EXHIBIT 1 - STAFF REPORT

DATE: July 25, 2018
TO: Historic Landmarks Committee Members
FROM: Chuck Darnell, Senior Planner
SUBJECT: HL 8-18 / DDR 8-18 – 337 NE Baker Street

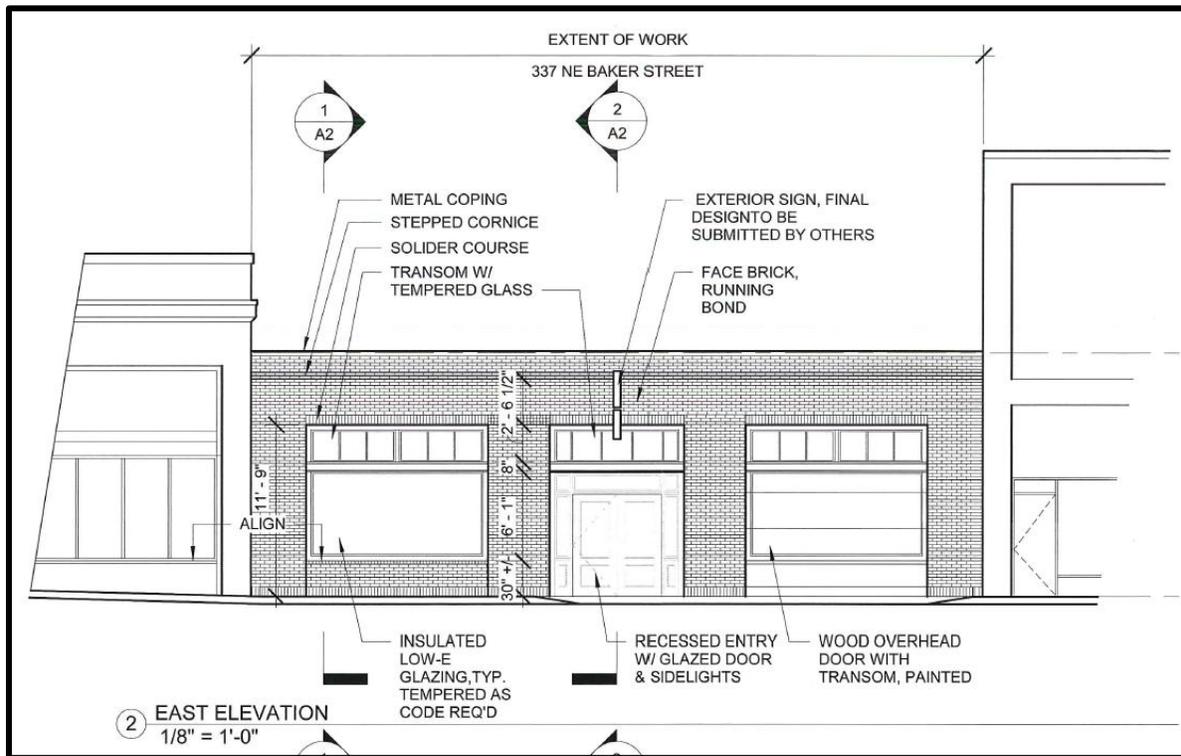
The proposed design meets most of the applicable storefront standards, other than the minimum 70 percent glazing requirement, which the applicant is requesting a design waiver from. That design waiver request will be discussed in more detail below.

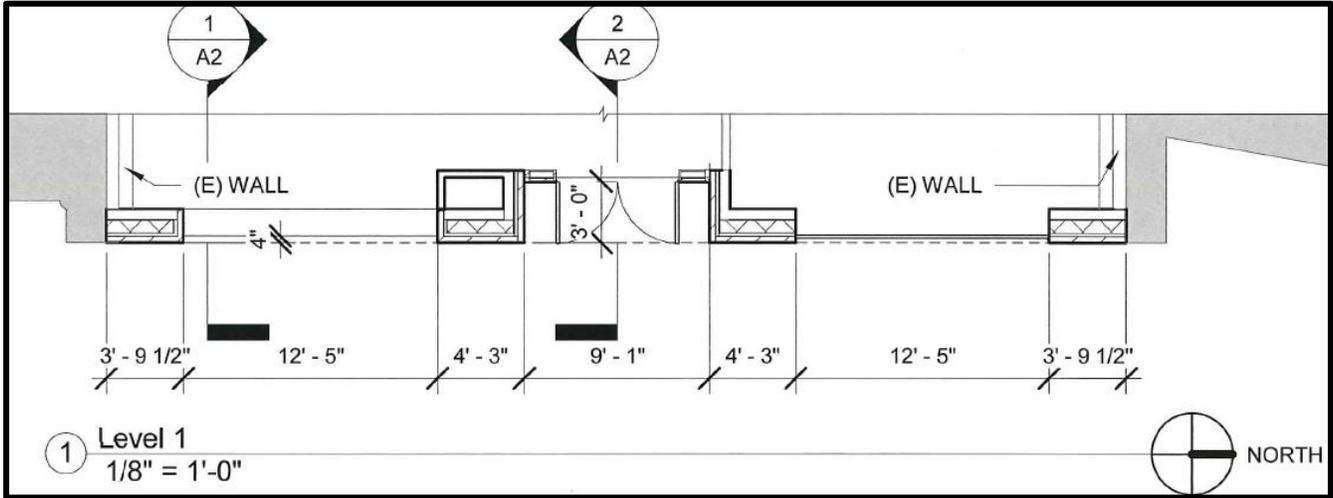
The building is only one story, so the standard related to a belt course separating stories is not applicable. The design includes a masonry bulkhead at the street level, consistent in height with adjacent buildings and with the historic design as documented in a circa 1940s photograph of the building. The design includes a recessed entry with transom windows, partially glazed doors, and sidelights on each side of the doors. The cap of the building will include a single stepped masonry cornice, consistent with the historic design as documented in a circa 1940s photograph of the building. The proposed design, which incorporates these features, can be seen below:

The proposed alterations will not change the roof lines of the original structure, which is flat and consistent with the rooflines of adjacent buildings.

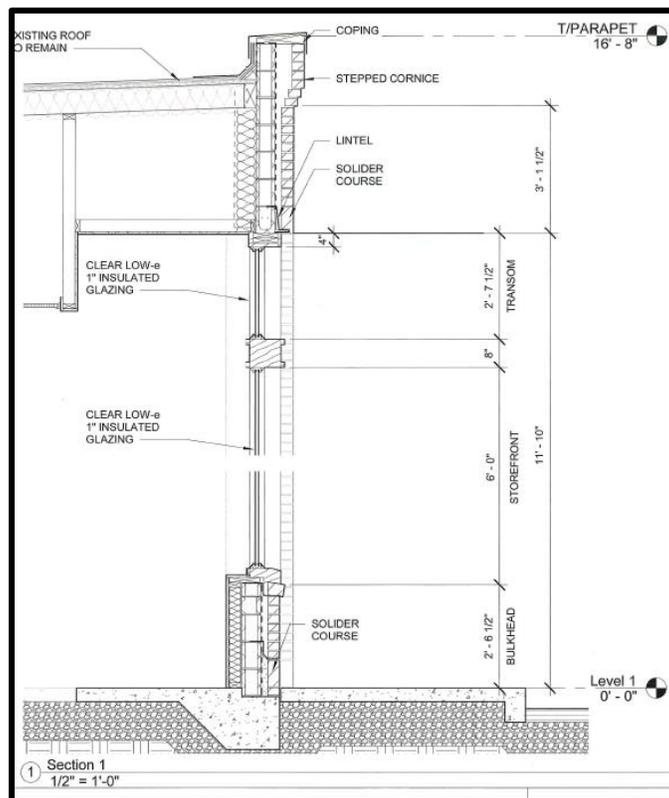
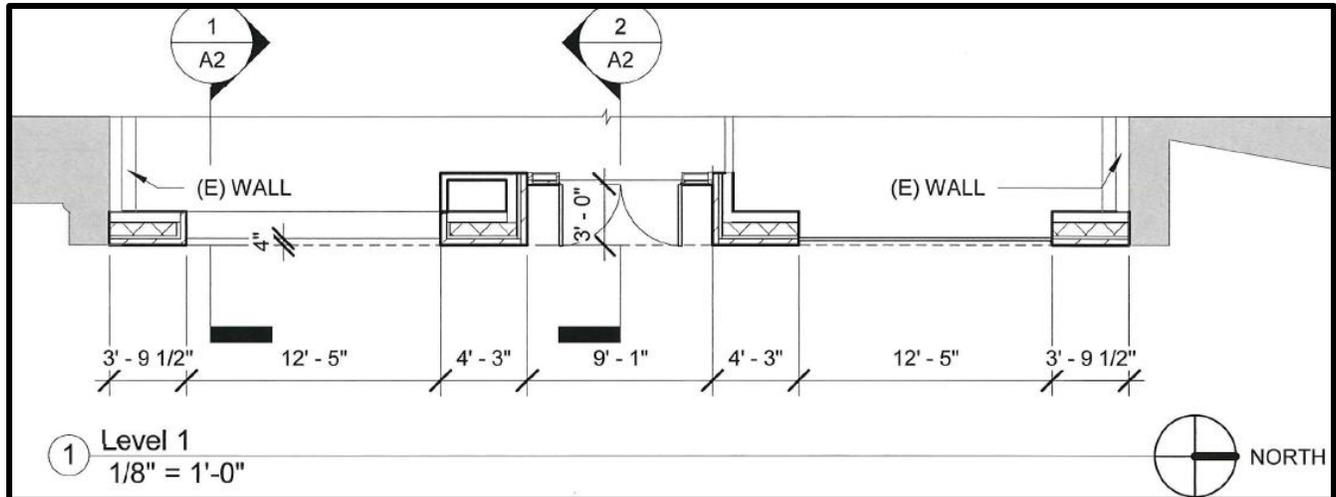
The windows are proposed to be recessed by 4 inches from the outer wall. The recessed windows are shown in the drawings below:
